City of Flint

TO: All Proposers
FROM: Lauren Rowley, Purchasing Manager
DATE: **April 02, 2026**
SUBJECT: **Addendum #01 – P26000534: CITY HALL SIDEWALK REPLACEMENTS**

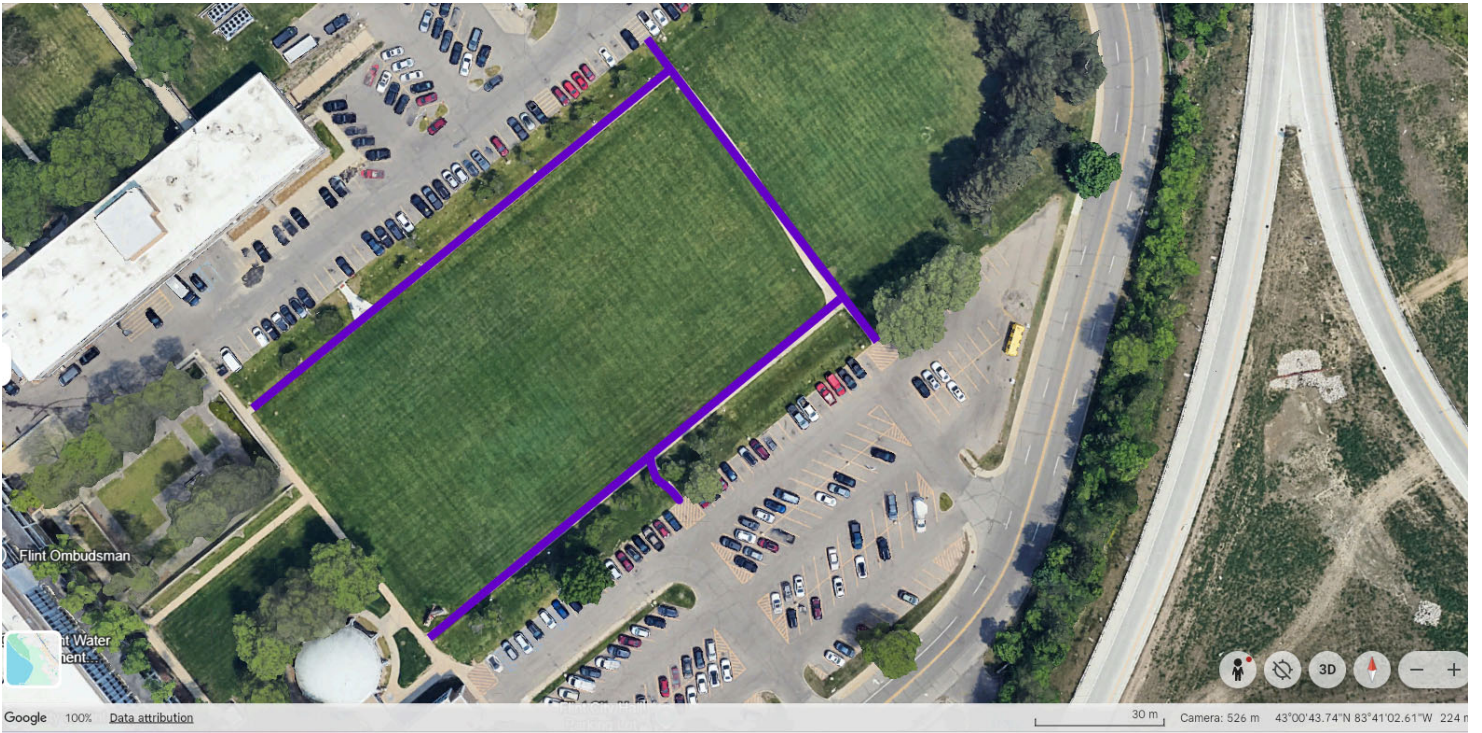
- 1.) The three pathways that go to the parking lots must be handicapped accessible (does not need plates) and the curb cut.**
- 2.) Just to reiterate, 3" of 23A aggregate base is required, along with 6" of concrete.**
- 3.) Restoration services are to include hydroseeding. It should be 4" of topsoil, along with hydroseeding. Attached is a new sidewalk pricing sheet.**
- 4.) An aerial photo indicating the locations of sidewalks needing replacement is attached.**
